ADDENDUM #1
19SWR22 SKINNER INDUSTRIAL DRIVE TRUNKMAIN
REPLACEMENT AND INTERSECTION IMPROVEMENTS
PROJECT
BID NO. 4468

The City of St. Charles is issuing this addendum to the Skinner Industrial Drive Trunkmain Replacement and Intersection Improvements Bid Documents. The purpose of the addendum is to acknowledge receipt of plan revisions and memorandum regarding Contractor's Request for Information. The revised bid information is as follows:

Memorandum

Subject: *Contractor's Request for Information*

G-003

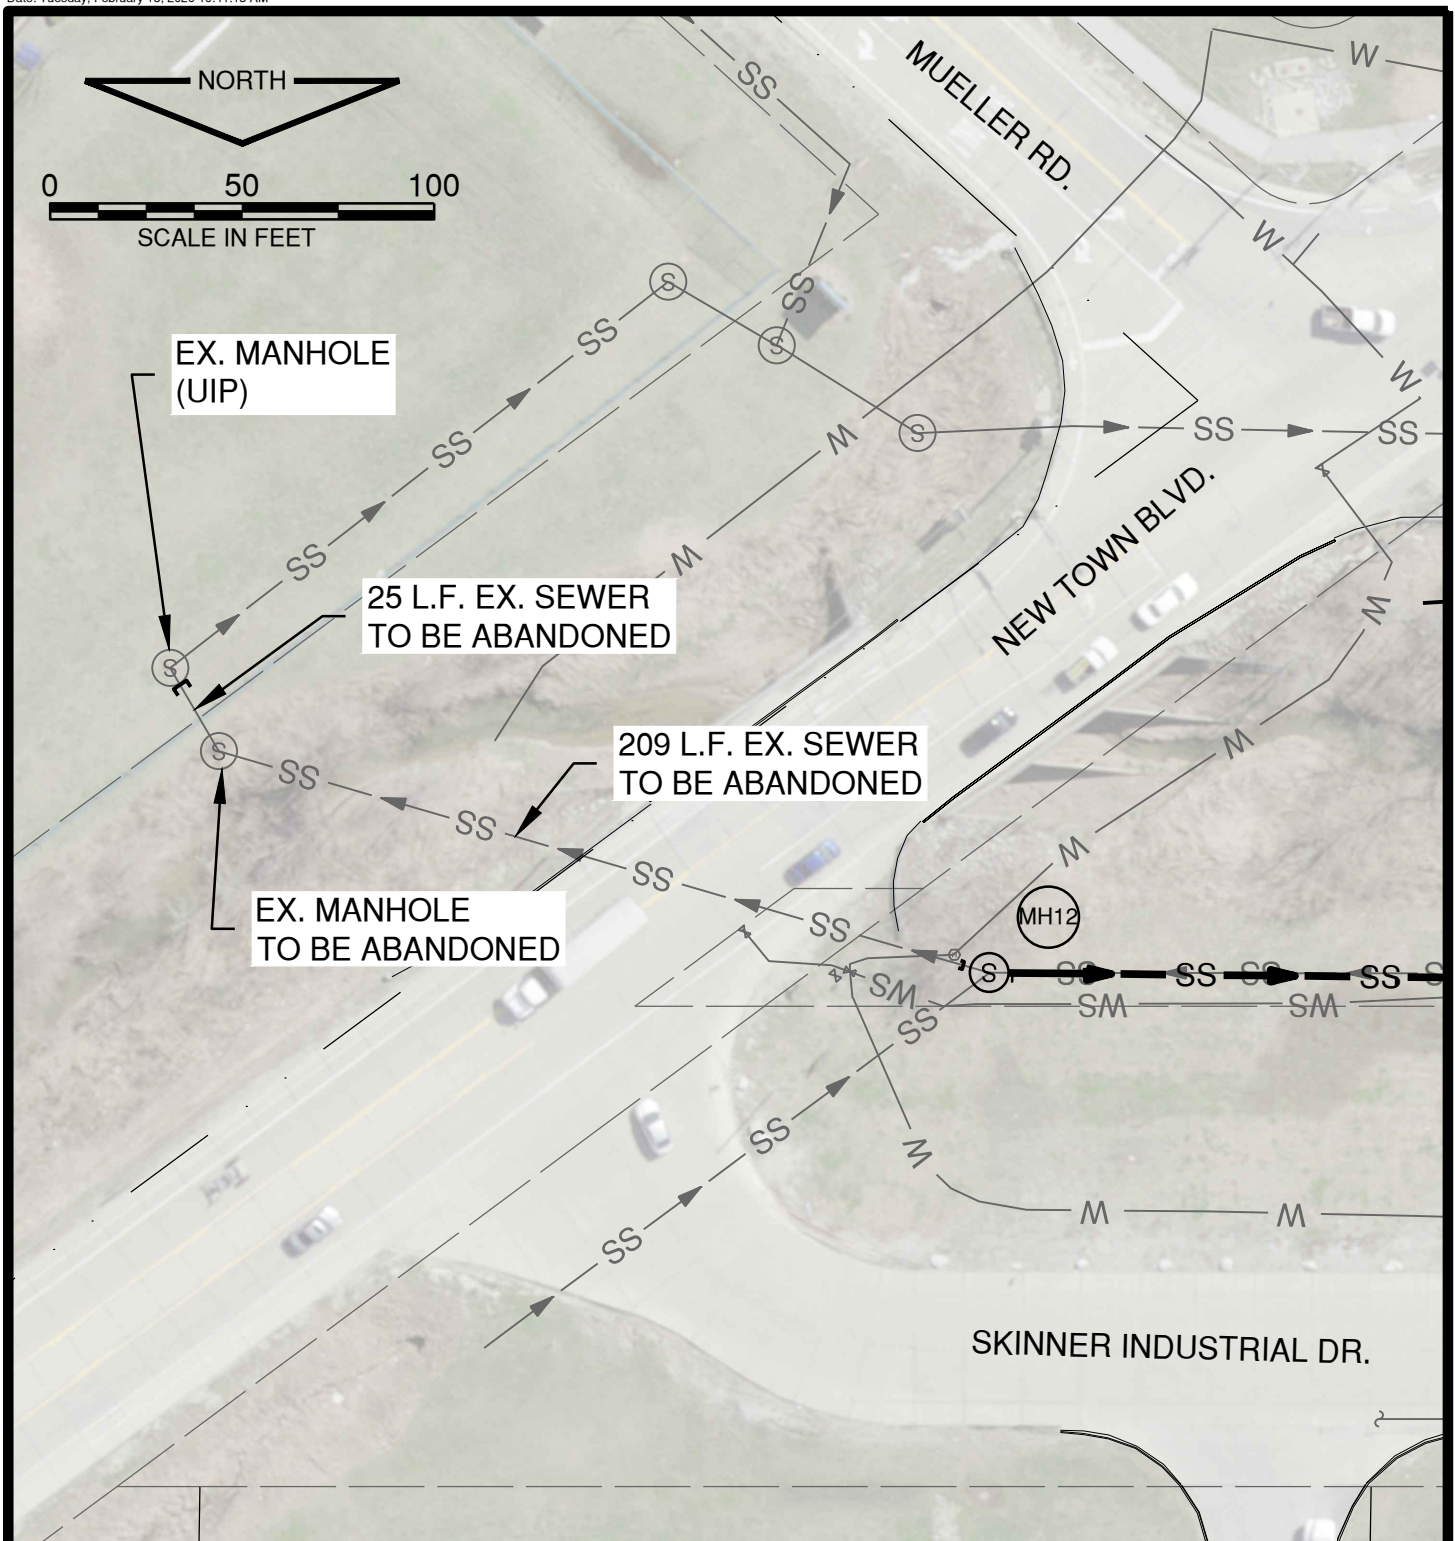
- 3. Enclosed is the revised plan sheet G-003 of the Sewer Construction Plans. The quantity table on the form was updated to match the revised Proposal form.**

1-6

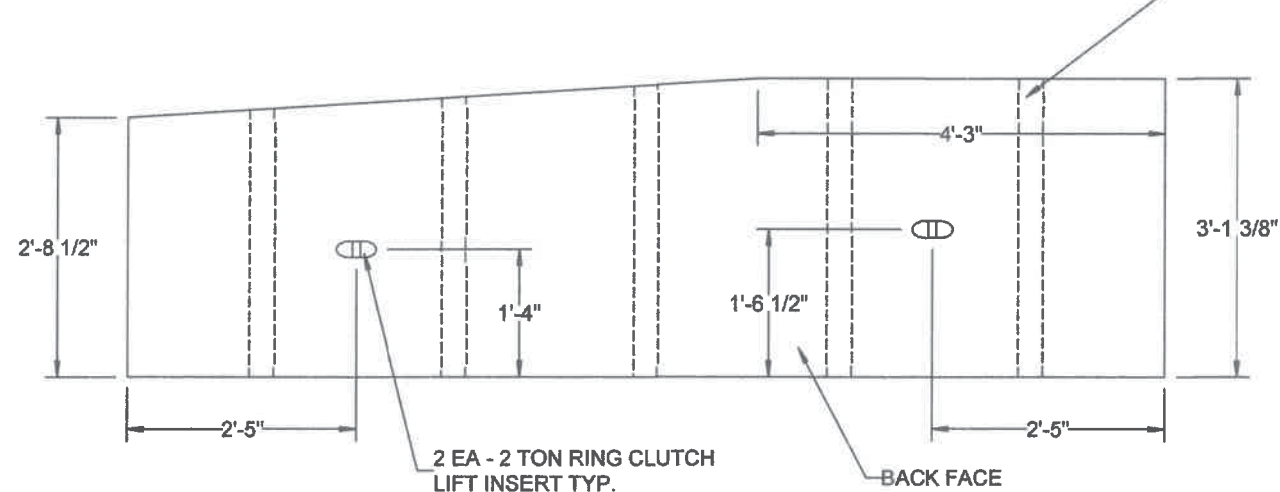
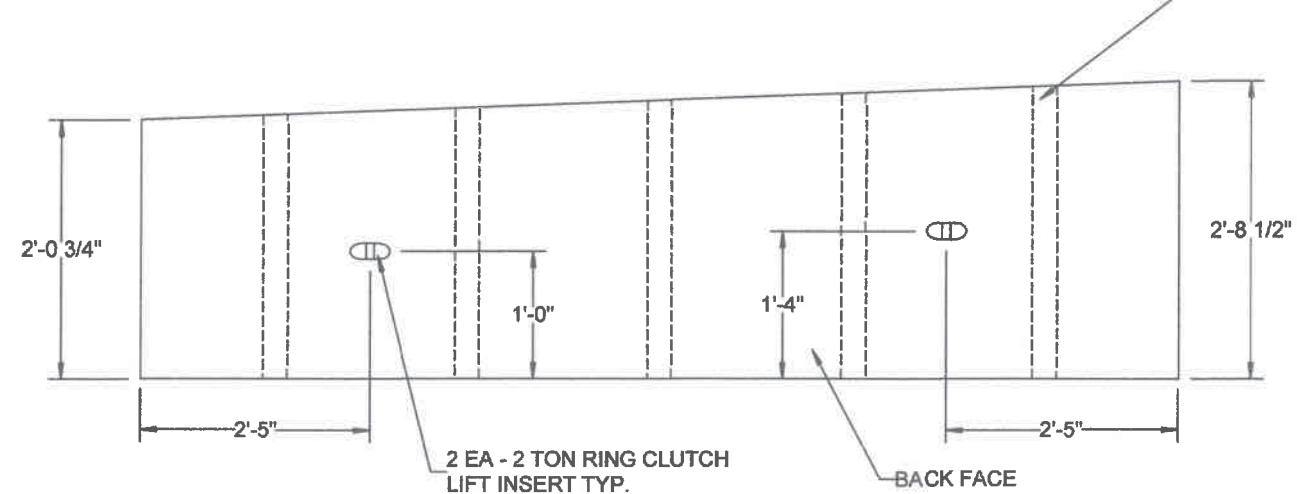
CONTRACTOR TO DRILL & EPOXY #5 REBAR INTO TOP OF PRECAST BARREL SECTION 9" & FILL VOID WITH GROUT

CONTRACTOR TO DRILL & EPOXY #5 REBAR INTO TOP OF PRECAST BARREL SECTION 9" & FILL VOID WITH GROUT
